1. Could you please advise if client has a designated area to process site won material neutralization/lime stabilization? **No, Council has not designated an area - it will be part of the tender for you to identify this.**
2. MRTS 14.1 has not been provided with the tender documents. Could the Council please issue this document? **I will follow up on this and get this document issued on the Council website as a notice for the tender.**

ACCESSES ALONG BITUMEN ROADS
ADT <300 VPD

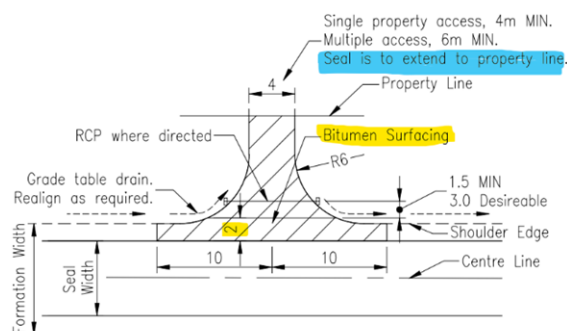
5. BOQ states seal for driveways to be provided up to 2m from the main road seal edge. Could you please confirm if the seal on driveways/access ways to private properties are to be provided as per the BOQ irrespective of the driveway construction notes on Drawings 0112-0019-0000-02, 0111-0019-9005-02, 0113-0019-9005-008 & 0113-0019-9005-009.

CMDG Drawing CMDG-R-040 requires that bitumen surfacing be added at least 2m from the edge of the road and that the seal is to extend to the property line – which is confusing. Please allow for bitumen surfacing to be applied between edge of the road and the property boundary of the relevant driveways.
